Docket No. 50-341

IE Bulletin No. 80-20

FAILURES OF WESTINGHOUSE TYPE W-2 SPRING RETURN TO NEUTRAL CONTROL SWITCHES

FIGURE 1:

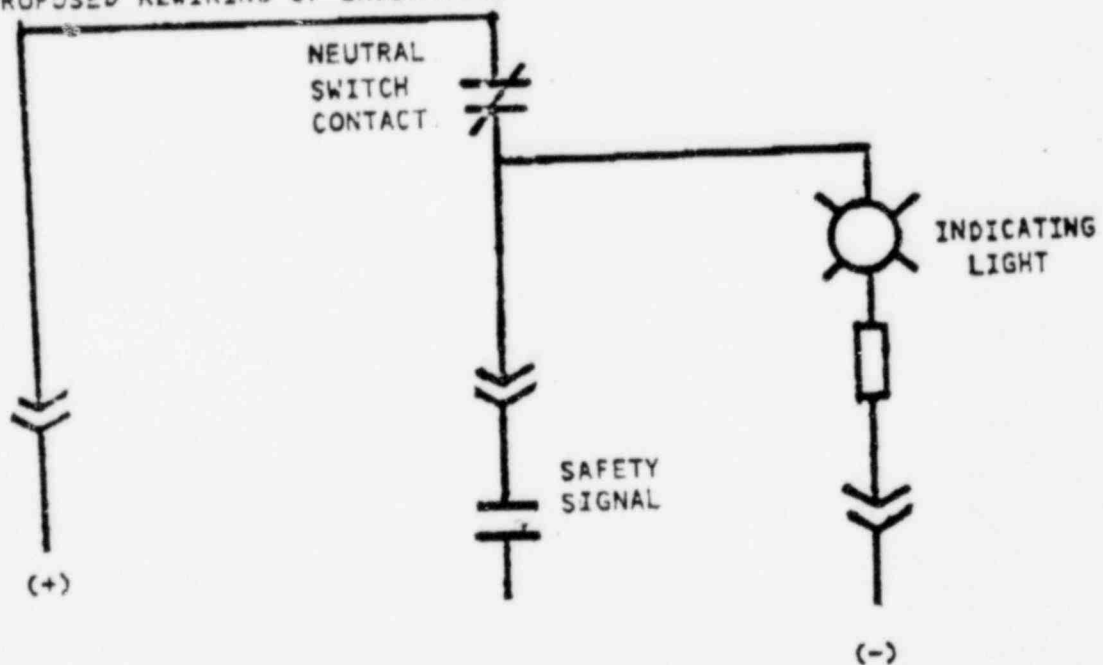
A review of this matter by Westinghouse led to the issuance of NSD Technical Bulletin No. NSD-TB-80-9 to the utility owners of all Westinghouse operating plants. The recommendations contained in the Westinghouse technical bulletin include: (i) testing the neutral position contacts of the subject W-2 switches for continuity, and (ii) rewiring of the indicating light circuit to permit the early detection of a neutral contact failure as shown in Figure 1.

Depending on how the indicating light circuit is wired, loss of continuity thru the neutral position contact of a W-2 switch could remain undetected until the equipment associated with the switch were called upon to operate. Since such a failure would be equivalent to by-passing the system associated with the switch, consideration should be given to rewiring the switches used in safety-related applications as shown in Figure 1. Such rewiring would provide an acceptable means for detecting contact failure, provided the indicating light is in the control room and readily visible by the operator. If the indicating light is not so located, consideration should be given to annunciating the neutral position contact failures at the control room to alert the operator of the inoperable status of a safety-related system. In addition, consideration should be given to adding redundant contacts to the W-2 switches or to replacing the W-2 switches with others having a more positive contact wiping action.

3. Licensees of operating plants and holders of construction permits shall describe the longer term corrective measures planned and the date by which such measures will be implemented by actual installation or by design change, as appropriate. As a minimum, the longer term corrective measures should include rewiring the indicating light as shown in Figure 1 provided the light is readily visible to the control room operator. If not, failures of the neutral position contacts should be annunciated in the control room.

REWIRING OF INDICATING LIGHT CIRCUIT OF W-2 SWITCHES  
AS RECOMMENDED BY WESTINGHOUSE TECHNICAL BULLETIN NSD-TB-80-9
